Access Compliance Report

Public Rights-of-Way

Intersection ID: 46495	Main Street: NEWBRIDGE_RD	Cross Street: BERE_ISLAND_DR	Location: NW
ADA ID: 01570302E809	Ramp Type: PerpDiag	Initial Pass/Fail: Fail	Overall Compliance: No
		Severity Score: 8.75

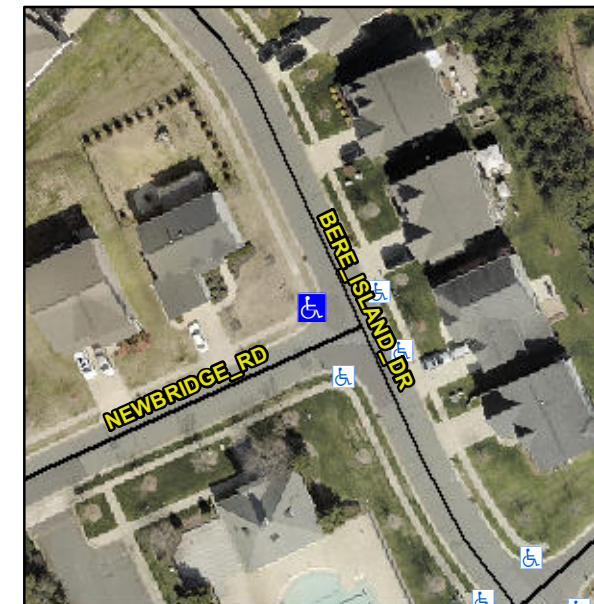
Not Found, R304.5.1

Compliance	Description	Data	Compliance	Description	Data
N/A	Ramp Length (in)	47.0	Yes	Ramp Slope (%)	5.5
No	Ramp Width (in)	45.5	Yes	Ramp XSlope (%)	1.2
N/A	Flare Type LT	N/A	N/A	Flare Type RT	N/A
N/A	Flare Slope LT (%)	N/A	N/A	Flare Slope RT (%)	N/A
N/A	Flare Traversable LT?	N/A	N/A	Flare Traversable RT?	N/A
N/A	Landing Length (in)	N/A	N/A	DWS Provided?	N/A
N/A	Landing Width (in)	N/A	N/A	DWS Contrast?	N/A
N/A	Landing Slope (%)	N/A	N/A	DWS Length (in)	N/A
N/A	Landing X Slope (%)	N/A	N/A	DWS Full Width?	N/A
N/A	Landing Curb? (Y/N)	N/A	N/A	DWS Offset (in)	N/A
N/A	Shared Landing?	N/A			
N/A	Gutter Ponding?	N/A	N/A	Gutter Slope (%)	N/A
N/A	Gutter Lip Ht (in)	N/A	N/A	Gutter X Slope (%)	N/A
N/A	Painted X Walk1?	No	N/A	Painted X Walk2?	No
	X Walk 1 Direction	To SE		X Walk 2 Direction	To NE
N/A	X Walk 1 Width (in)	N/A	N/A	X Walk 2 Width (in)	N/A
	X Walk 1 Slope (%)	2.0		X Walk 2 Slope (%)	4.2
	X Walk 1 X Slope (%)	0.4		X Walk 2 X Slope (%)	2.0

Remove & Replace Curb Ramp With Two New Directional Ramps or Equivalent.
